ATS & PFSP YANG maintenance items #0392 & #0393 ver 1.1

Maintenance items

- ATS schedulers and scheduler-groups YANG containers don't align with 802.1Q-2022
- Multiple Scheduler Instance Tables and Scheduler Group Instance Tables are created in a bridge components
- Will discuss this in today's call

- Need a clarification of using stream-filter when a bridge uses both ATS and PSFP

Figure 8-15—Per-stream classification and metering for ATS

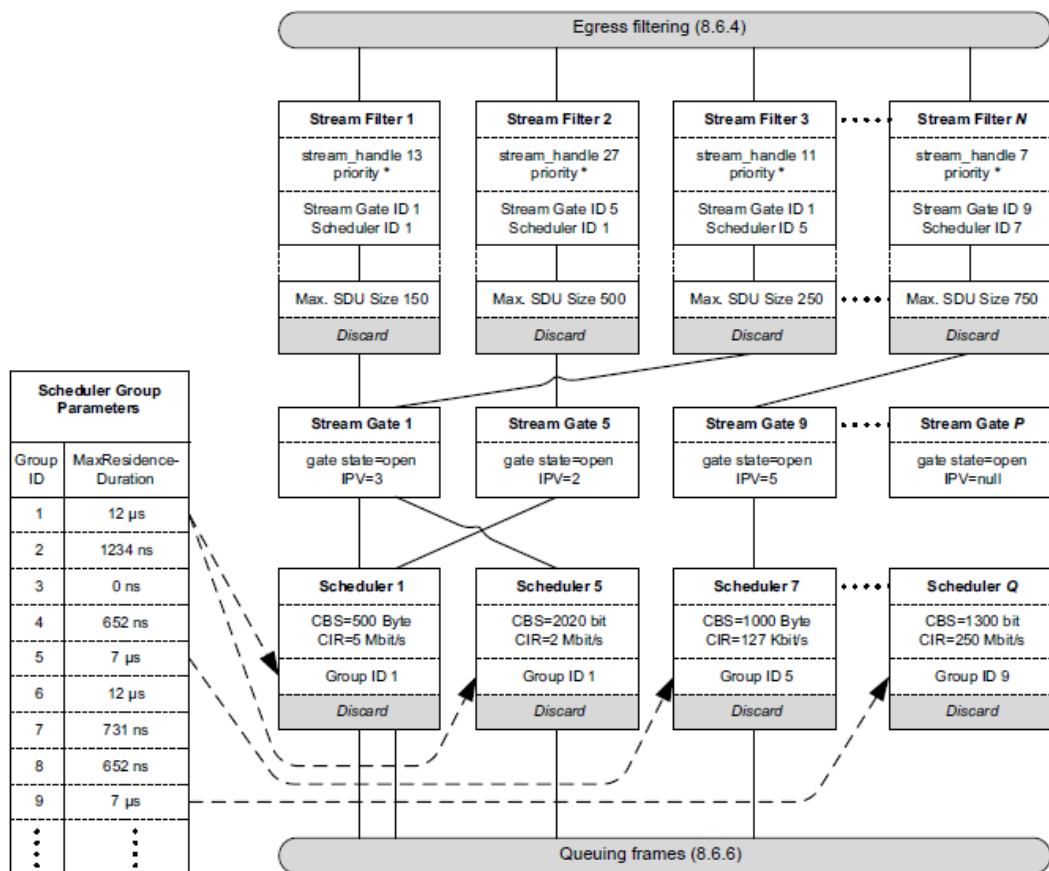
ATS schedulers and scheduler-groups YANG containers
don't align with 802.1Q-2022

Each Bridge component that implements *ATS* shall support *stream filtering*, *maximum SDU size filtering*, *stream gates supporting IPV assignment*, *ATS schedulers*, and *ATS scheduler groups*, with the following:

- A single *Stream Filter Instance Table* (8.6.5.3).
- A single *Stream Gate Instance Table* (8.6.5.4). If the Bridge component does not support PSFP in addition to ATS, each stream gate only supports IPV assignment (8.6.5.4). IPV can be used as part of adjusting per-hop delay bounds to meet specific networks' end-to-end delay requirements.
- A single *ATS Scheduler Instance Table* (8.6.5.6).
- A single *ATS Scheduler Group Instance Table* (8.6.5.6).
- An *ATS Port Parameter Table* for each Bridge Port (8.6.5.6).

Figure 48-15—Stream filters and stream gates model

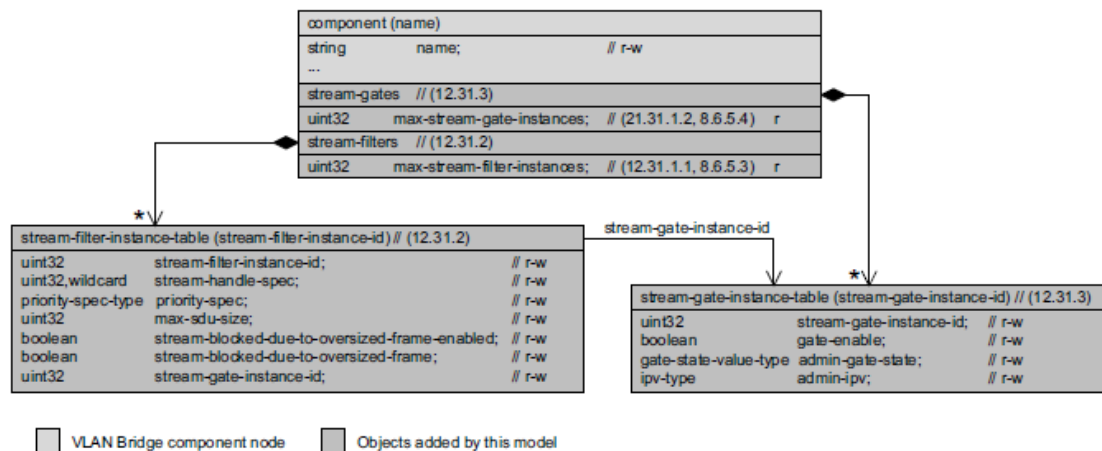
- **48.2.6 Stream filters and stream gates model**
 - The stream filters and stream gates model augments the Bridge component model (48.3.1) by nodes that represent the following managed objects:
 - a) Stream Filter Instance Table (12.31.2)
 - b) Stream Gate Instance Table (12.31.3)

- Look there was a disconnection when updating ATS YANG for PSFP/ATS/CI in Qcz-2023. [contribution #1](#) & [contribution #2](#)
- ATS YANG module (clause 48.5.13) includes *scheduler-instance table* and *scheduler-group-instance-table* under *stream-filter-instance-table[]*. This causes multiple *scheduler-instance-tables* and *scheduler-group-instance-tables* under *stream-filter-instance-table[]*
- However, Clause 12.31.5 & 12.31.6 state
 - There is *one Scheduler Instance Table* per Bridge Component. ...
 - There is *one Scheduler Group Instance Table* per Bridge Component. ...
- YANG and statements of clause 8.6.5.6, clause 12.31.5, clause 12.31.6, clause 48.2.6 & clause 48.2.7 don't match.

- Rollback to Qcr-2020 YANG by moving “*container schedulers*” and “*container scheduler-groups*” out from “*grouping ats-parameters*” of ieee802-dot1q-ats YANG module to as a container under “*augment “/dot1q:bridges/dot1q:bridge/dot1q:component”*”
- Need to confirm this change does not break other part such as PSFP and CI especially End-Station cases.

Figure 48-16—Asynchronous Traffic Shaping model

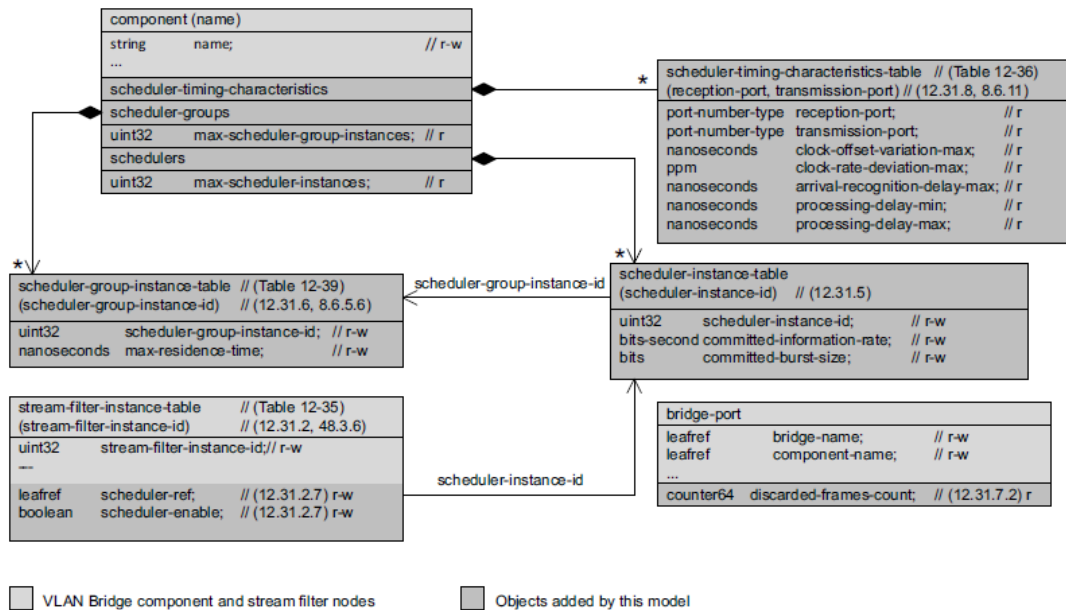
• 48.2.7 Asynchronous Traffic Shaping (ATS) model

- The ATS model augments the Bridge component model (48.3.1) and the stream filters and stream gates model (48.3.6) by nodes that represent to following managed objects:

- a) The Scheduler Instance Table (12.31.5)
- b) The Scheduler Group Instance Table (12.31.6)
- c) The Scheduler Port Parameter Table (12.31.7)
- d) The Scheduler Timing Characteristics Table (12.31.8)
- e) A Stream Filter specification type representing an ATS scheduler instance identifier (12.31.2.5)

Figure 8-13—Flow classification and metering

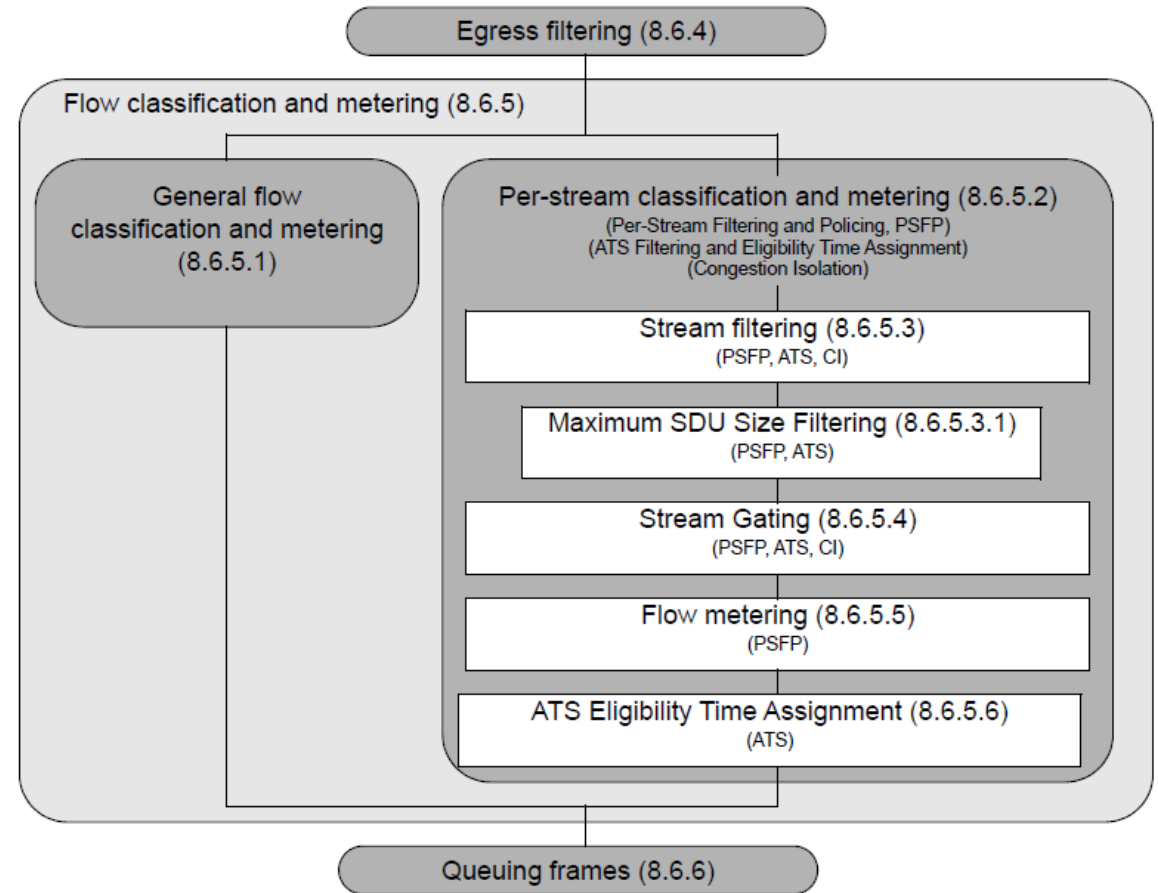
- **8.6.5 states**
 - “PSFP and ATS share common per-stream classification and metering elements, as shown in Figure 8-13.”
- **8.6.5.2 d) states**
 - “... A given stream filter can be configured with flow meters and an ATS scheduler if both PSFP and ATS are supported.”
- **8.6.5.2.2 b) states**
 - “If the Bridge component does not support PSFP in addition to ATS, each stream gate only supports IPV assignment. ...”
 - NOTE 2—For bridges with support for ATS, and without support for PSFP, stream gates of ATS traffic will never close. In this case, stream gates are only used for IPV assignment.

- **802.1-2022 (and P802.1-2022-Rev-D1.6) states that “*PSFP and ATS share common per-stream classification and metering elements, as shown in Figure 8-13.*”**

But, no clear mention (or definition) that each function (or module) can/shall have own stream-filter table.

- **We think this should be clarified in 802.1Q that how *stream-filter* and *stream-gate* are defined/used when multiple functions of PSFP, ATS and CI are used in a bridge.**
